(E) January 2010
Install video detection
3 BID 27861T21002

MDOT - STATE HIGHWAY ADMINISTRATION
Office of Traffic & Safety
TRAFFIC ENGINEERING DESIGN DIVISION
(Traffic Signal Plan)

US 40 at Eastern Blvd.

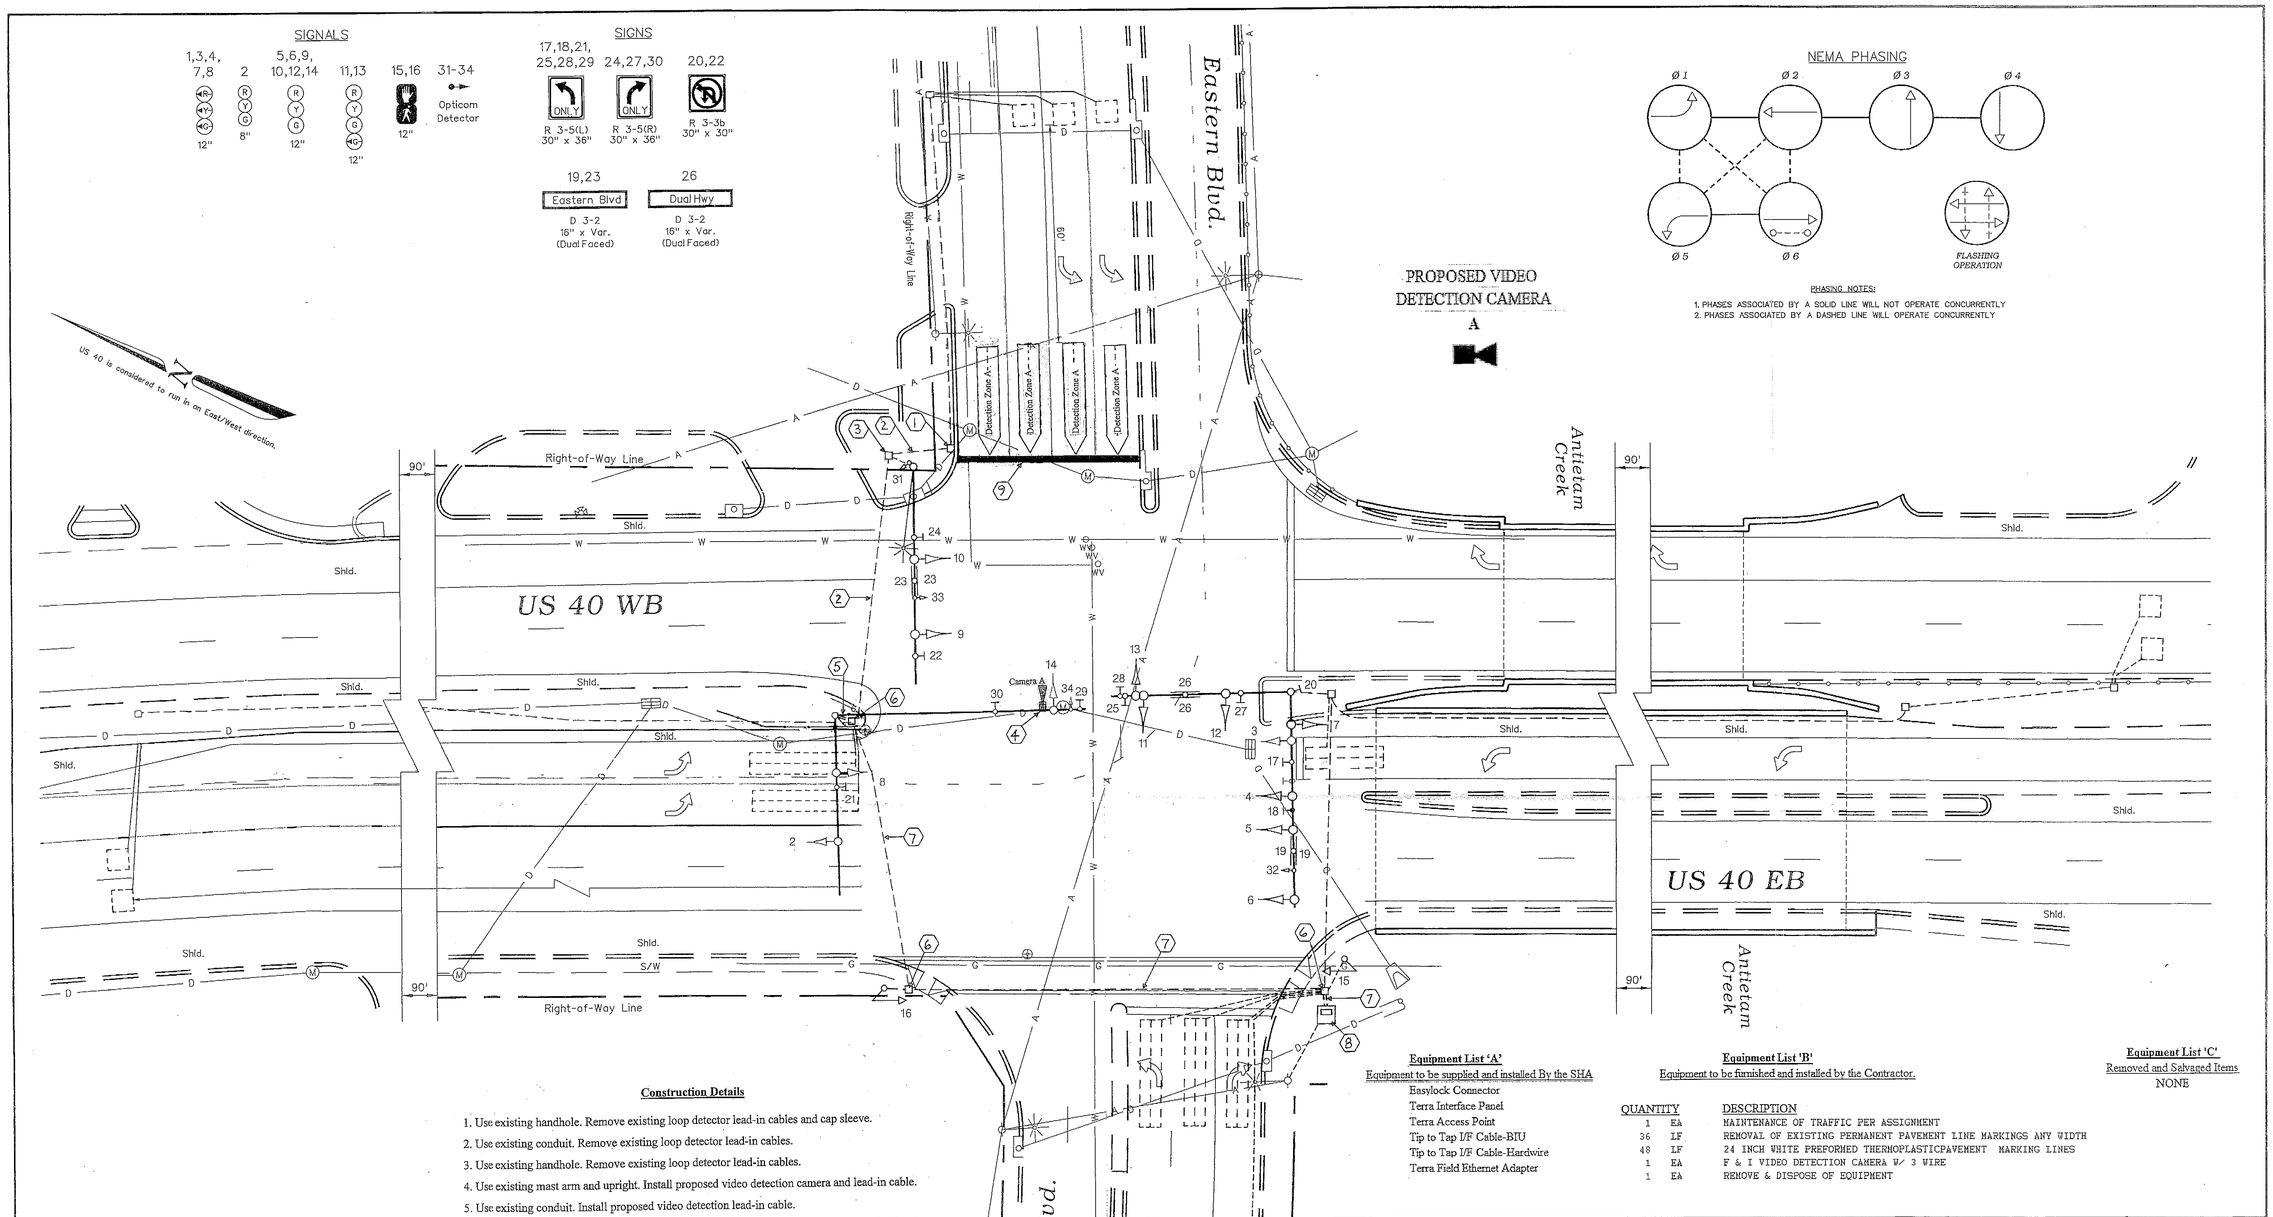
1. Use existing handhole. Remove existing loop detector lead-in cables and cap sleeve.
2. Use existing conduit. Remove existing loop detector lead-in cables.

3. Use existing handhole. Remove existing loop detector lead-in cables.
4. Use existing mast arm and upright. Install proposed video detection camera and lead-in cable.

5. Use existing conduit. Install proposed video detection lead-in cable.
6. Use existing handhole. Remove existing loop detector lead-in cables. Install proposed video detection lead-in cable.

7. Use existing conduit. Remove existing loop detector lead-in cables. Install proposed video detection lead-in cable.
8. Use existing controller cabinet. Remove existing loop detector lead-in cables for phase 4. Install proposed video detection lead-in cable. Traffic Operations Division personnel will Install and program video detection interface equipment upon completion of proposed work.

9. Remove existing stop line and replace stop line in accordance with SHA Standards.
